MANDATORY SERVICE BULLETIN

MSB 40NG-016/2

Type: DA 40 NG

Correction of Airspeed Indicator (ASI) markings.

G1000 equipped airplanes:

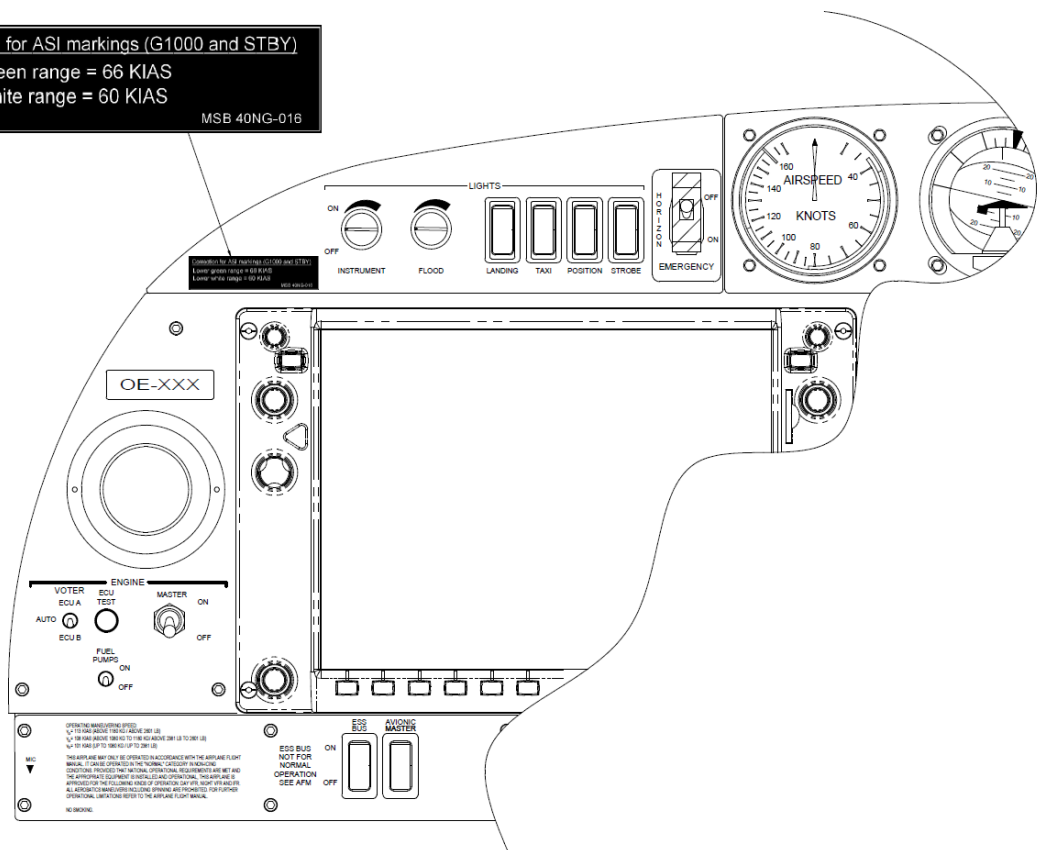
Correction for ASI markings (G1000 and STBY)
 Lower green range = 66 KIAS
 Lower white range = 60 KIAS
 MSB 40NG-016

Correction for ASI markings (G1000 and STBY)
 Lower green range = 66 KIAS
 Lower white range = 60 KIAS
 MSB 40NG-016

Airplanes with conventional cockpit:

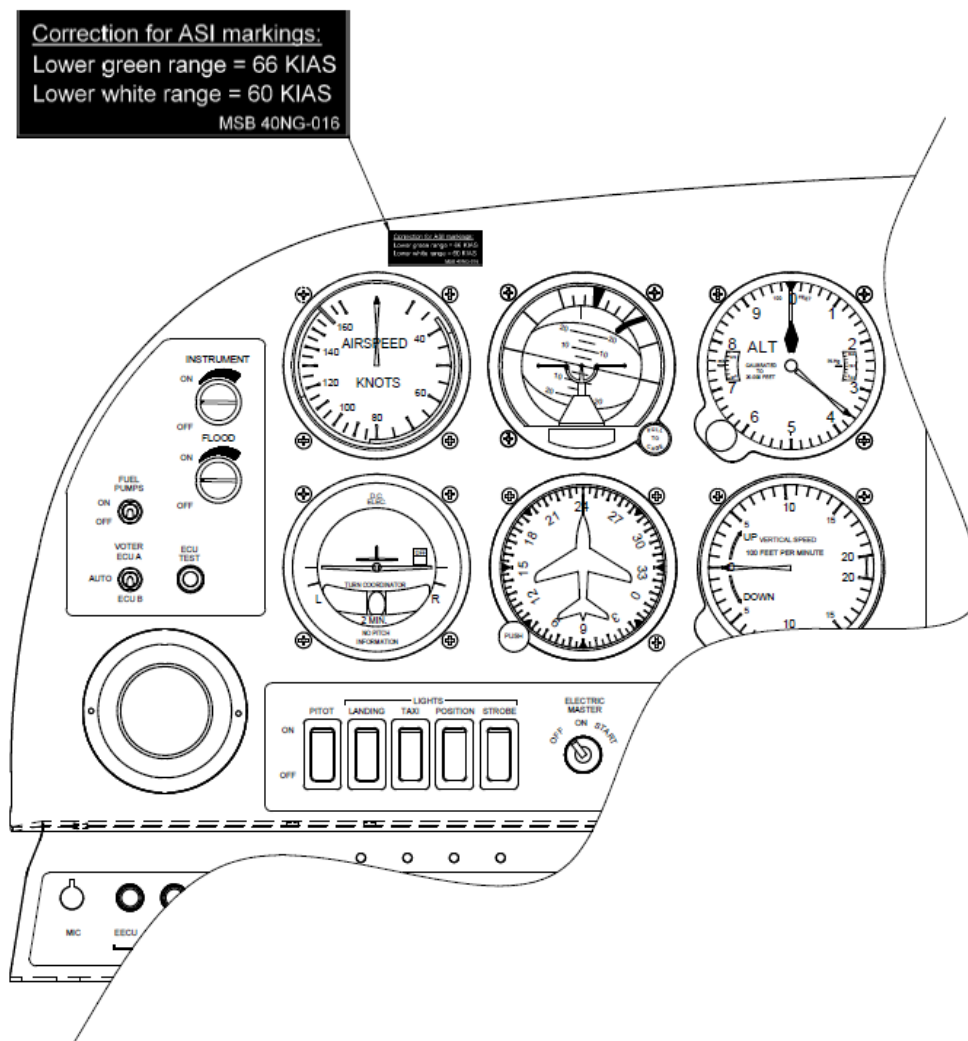
Correction for ASI markings:
Lower green range = 66 KIAS
Lower white range = 60 KIAS
MSB 40NG-016
